CITY OF SWEET HOME PLANNING COMMISSION AGENDA

Staff Report Presented to the Planning Commission

INTERIM STREET PLAN
 TENTATIVE SUBDIVISION
 TAX MAP 13S-1E-32CA
 LOT 4403
 SWEET HOME, OREGON

Staff Report Presented to the Planning Commission - *REVISED*

Sheet **C102**
 SCALE: SEE BARSCALE

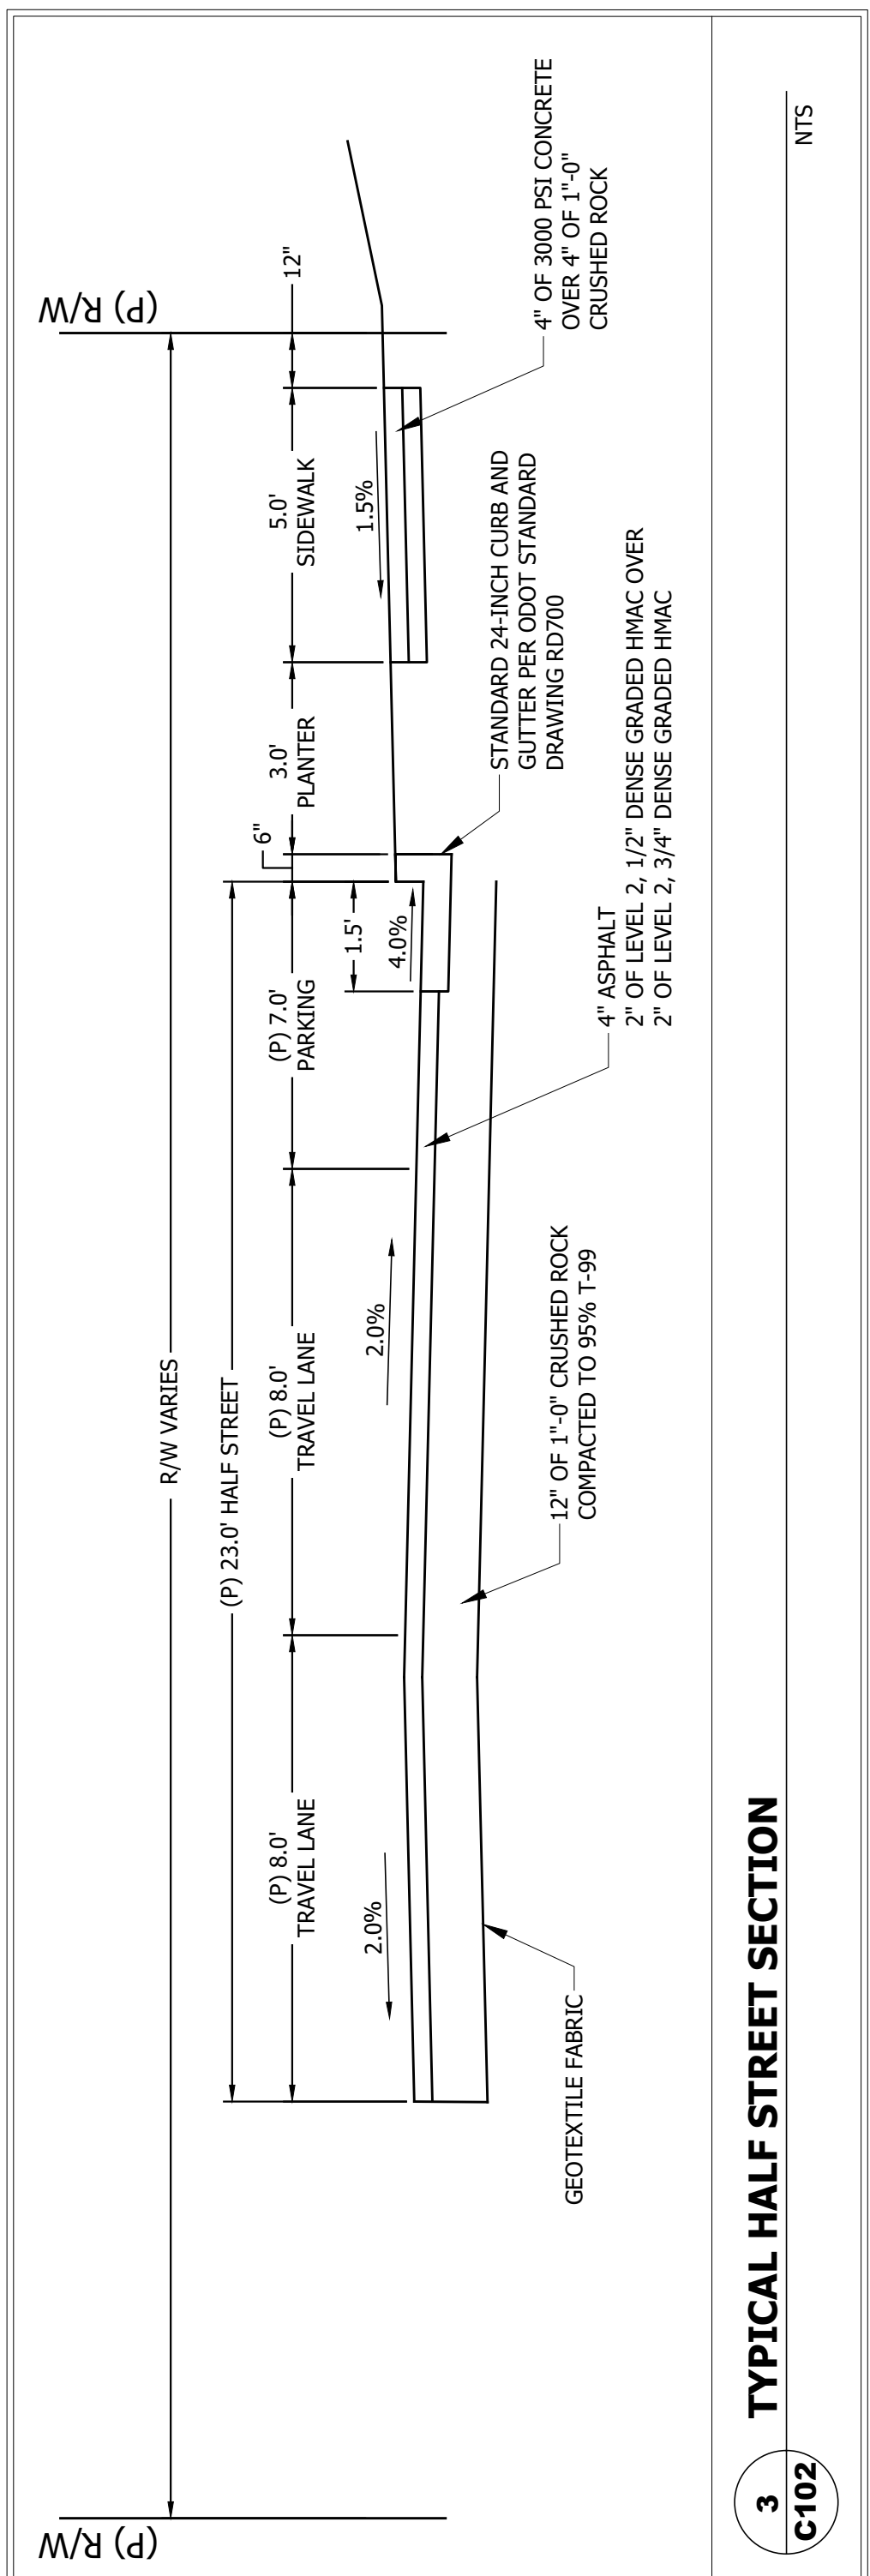
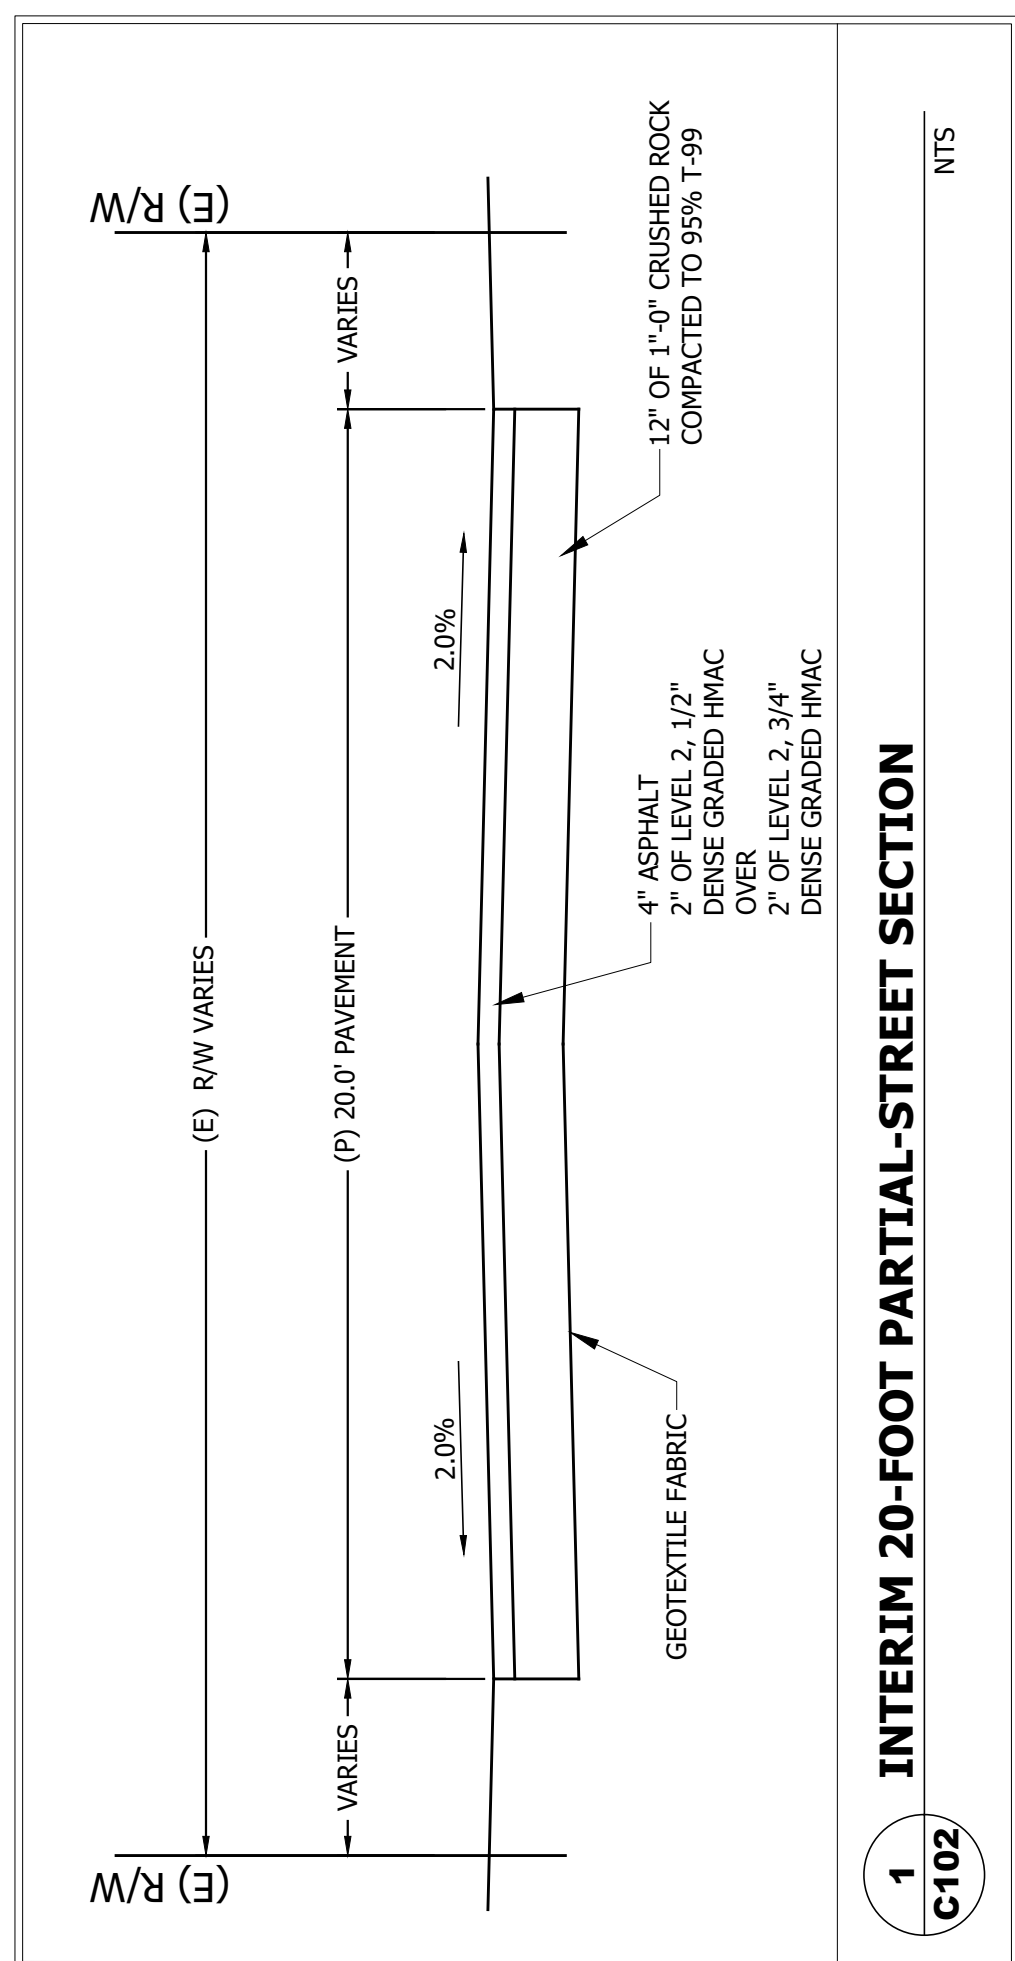
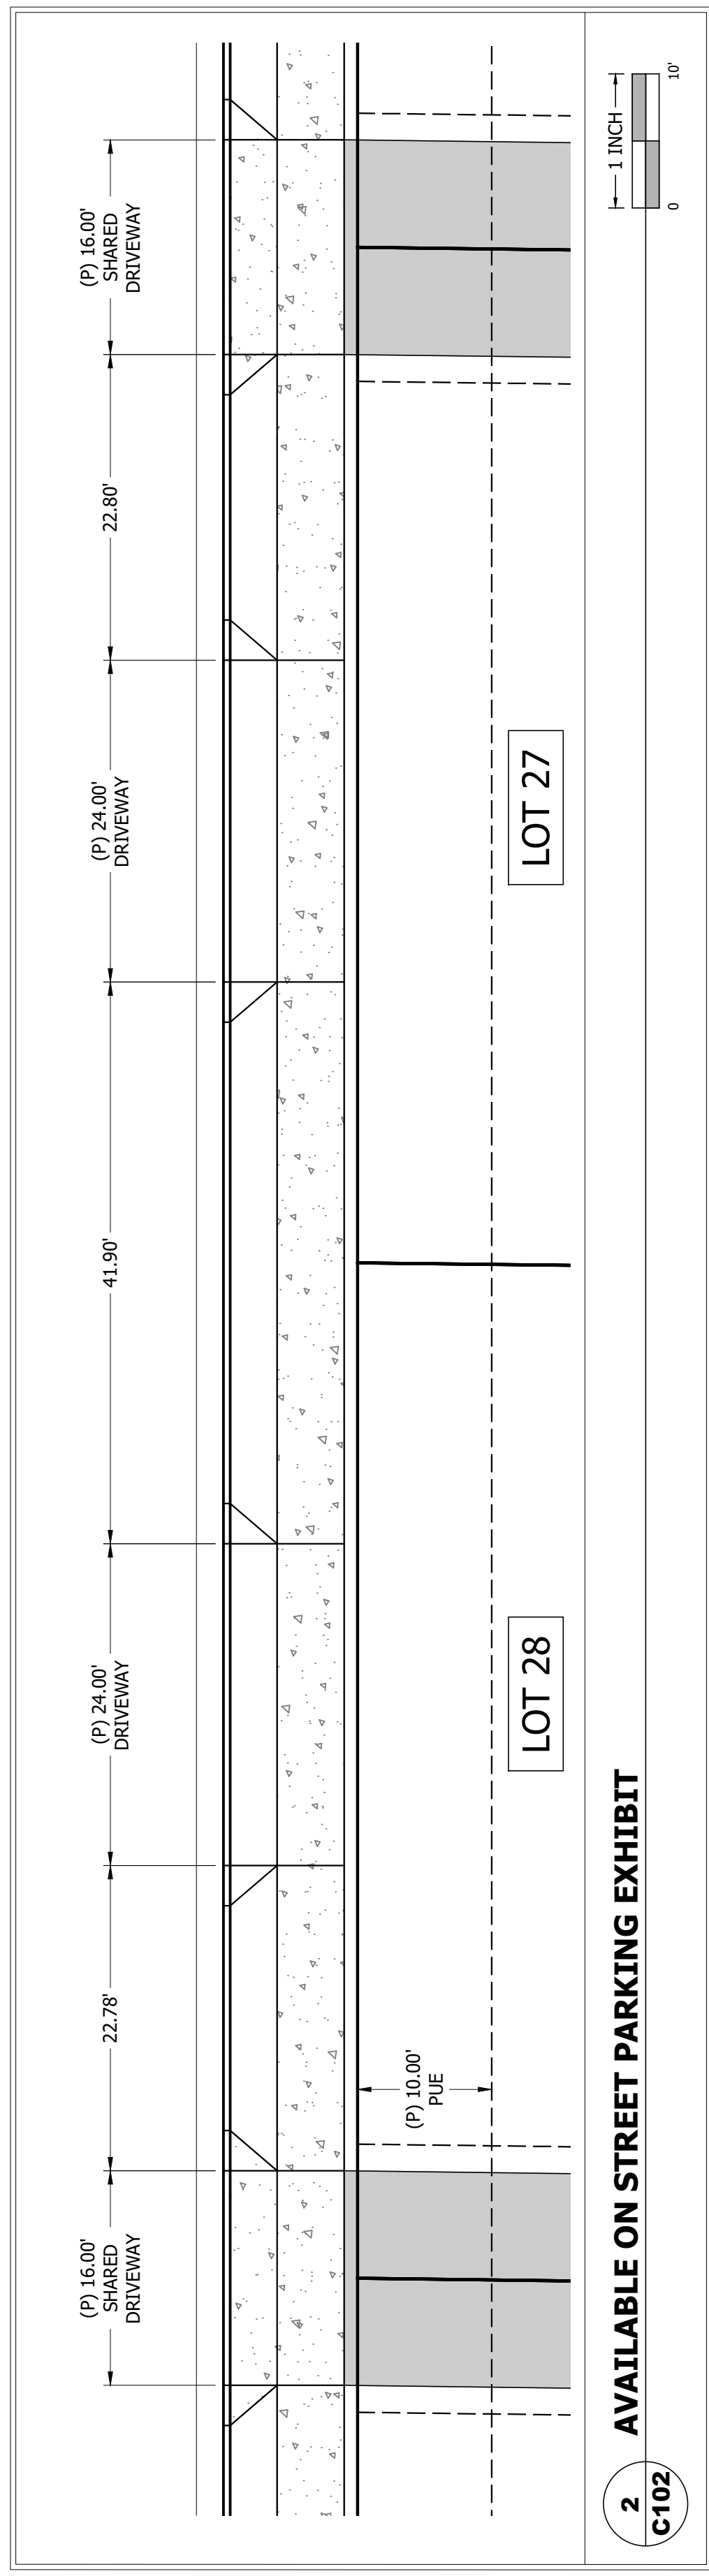
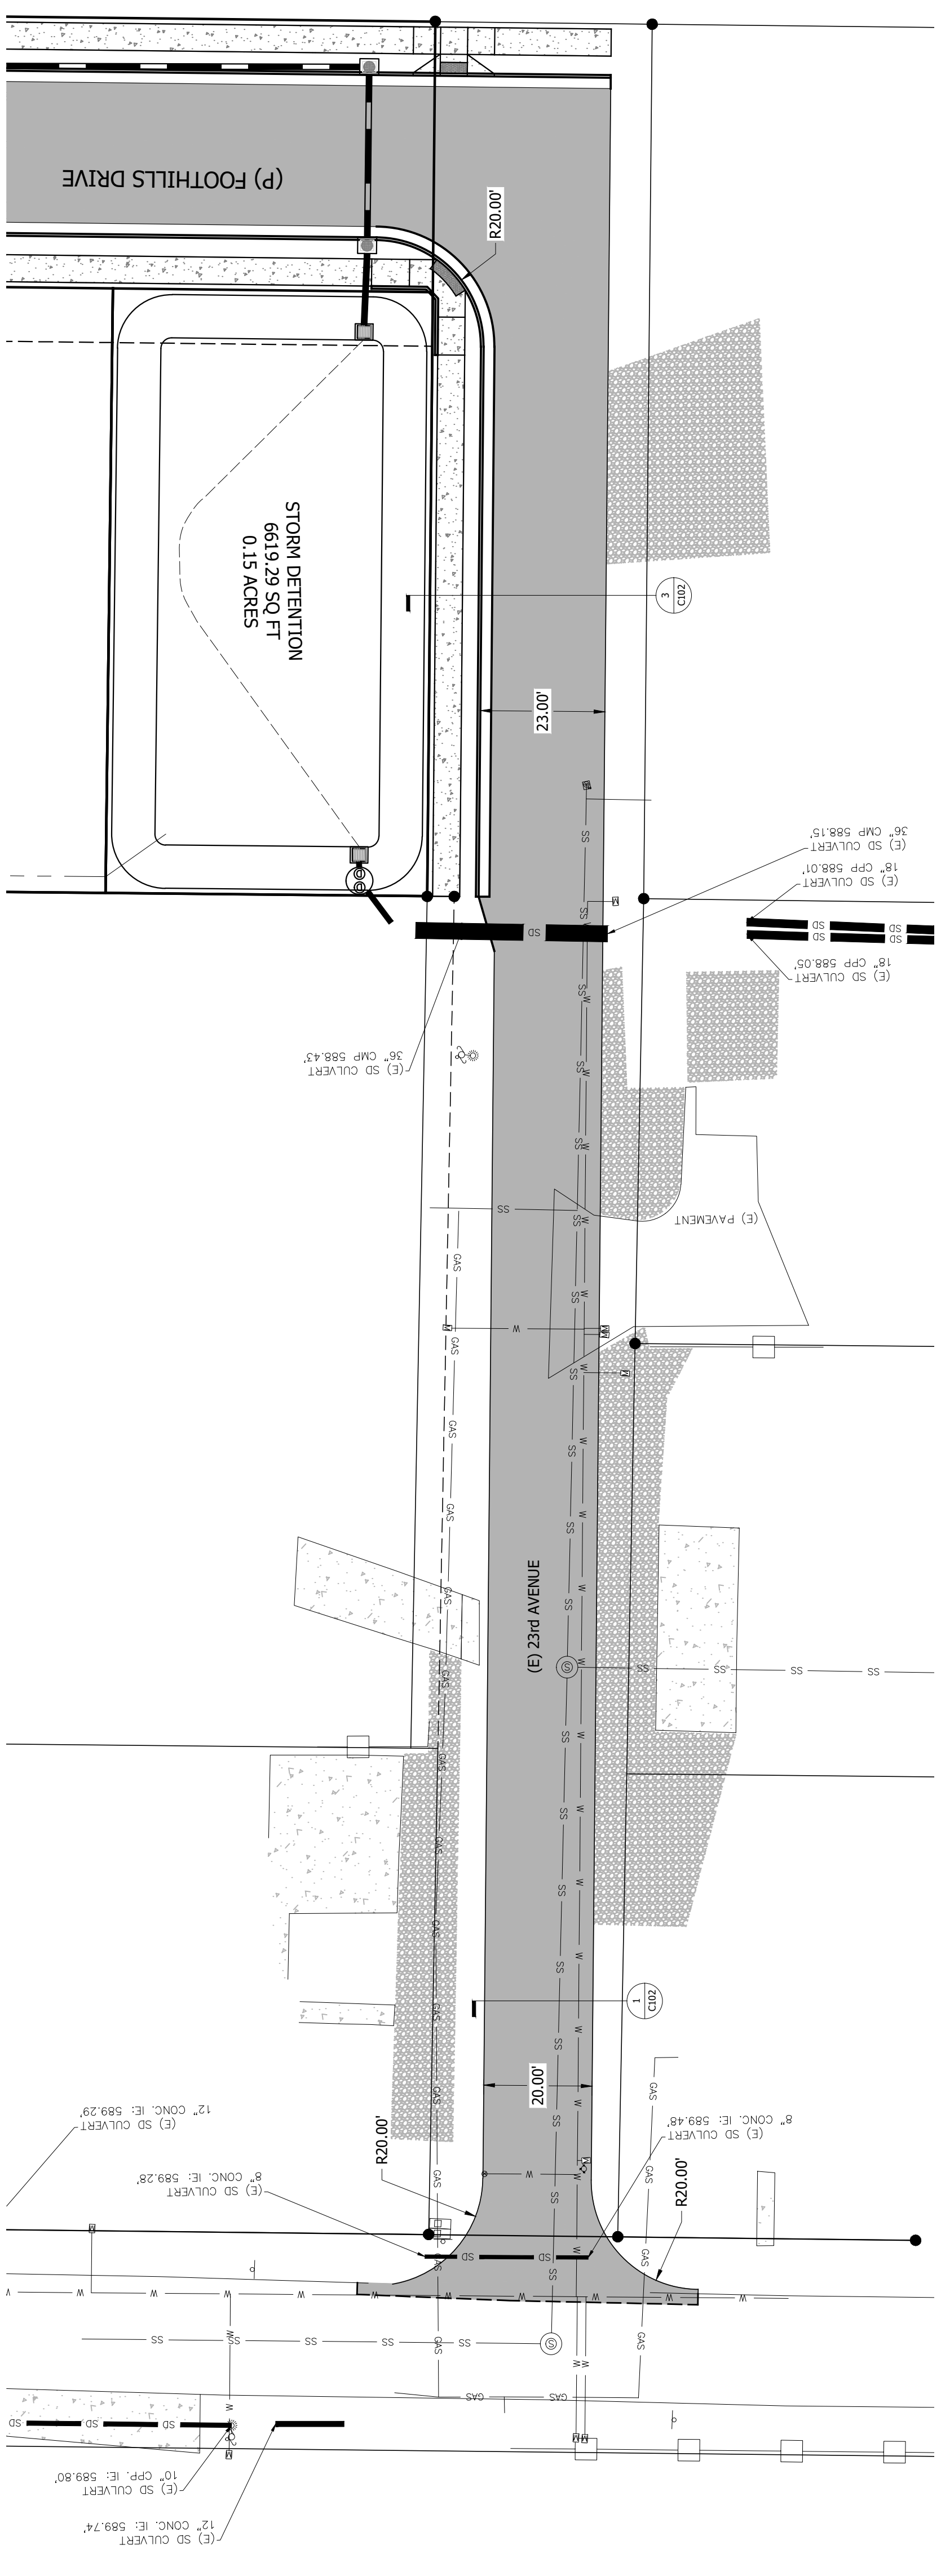
~~SHMC 17.42.040 requires a minimum 3-foot planter strip for Local Streets which the narrative and plan do not show. Foothills Drive is wide enough for planter strips to be constructed and are required. The proposal shows a 50-foot right-of-way, which provides adequate width on each side for 5-foot sidewalk, 3-foot planter, and a 6-inch curb which provides the minimum 7ft parking and travel lanes, etc. Attachment B, Sheet C102 shows a 3-foot planter strip.~~
